**Town of Williamsport
Request for Proposals
2022-1
Commerce-Salisbury
Sanitary Sewer Lining Project**

SCOPE OF ADDENDUM #1 – October 21, 2022

EXHIBIT B

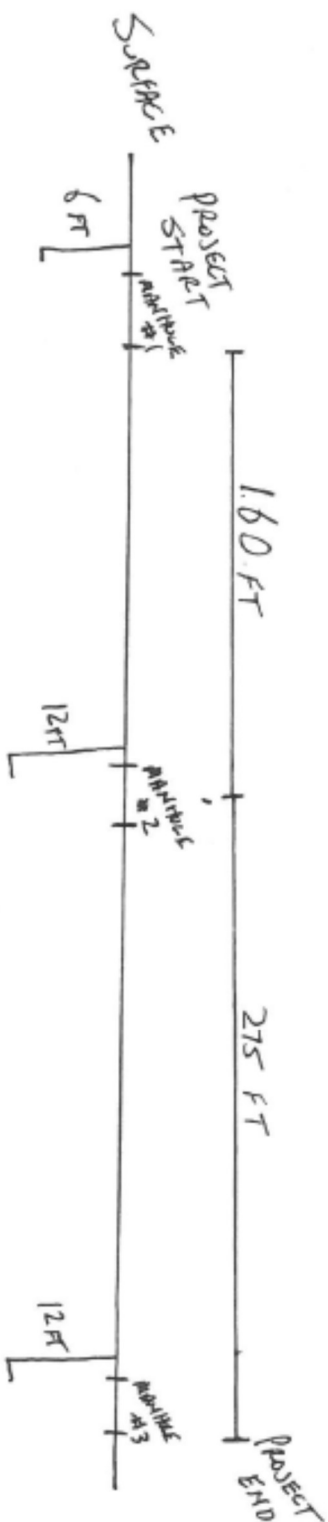
Revision 1: Adjust project total to 435 linear feet; 160 linear feet from identified Manhole #1 to Manhole #2 and 275 linear feet from Manhole #2 to Manhole #3.

Revision 2: Add Exhibit B depicting the depths of the three manholes and linear feet of the pipes to be serviced as part of this project.
